## **Submit comment on September 15 and 17 Working Group**

Initiative: Resource adequacy enhancements

### **1. Provide a summary of your organization's comments on the September 15 and 17, 2020 working group discussion:**

# California-Oregon Interface ( AC intertie)

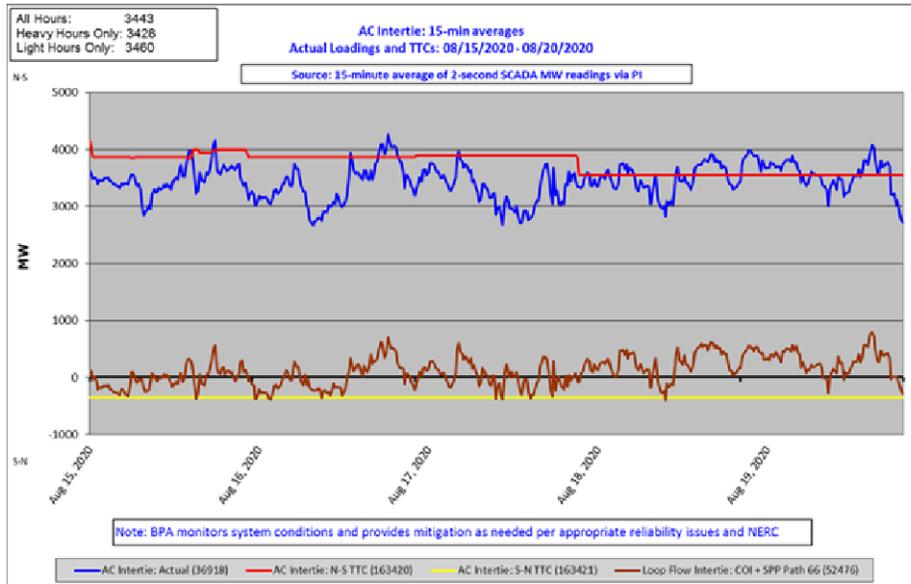
The good news is that the data CAISO included in Slides 116 and 117 demonstrate that even during extremely stressed system conditions from August 15, 2020 through August 20, 2020, the amount of power flow on the California-Oregon Interface and the Nevada-Oregon Border intertie were near (or even slightly above) the respective Total Transfer Capability of those interties. This was the case even without the more stringent firm transmission requirements that CAISO is considering implementing. In contrast, the flowgate data CAISO included on Slides 98 – 100 show that those flowgates were not binding during stressed conditions. If CAISO is concerned about the deliverability of import RA resources, CAISO could put limits on the amount of RA import resources shown that are located on the constrained side of the most critical flowgates.
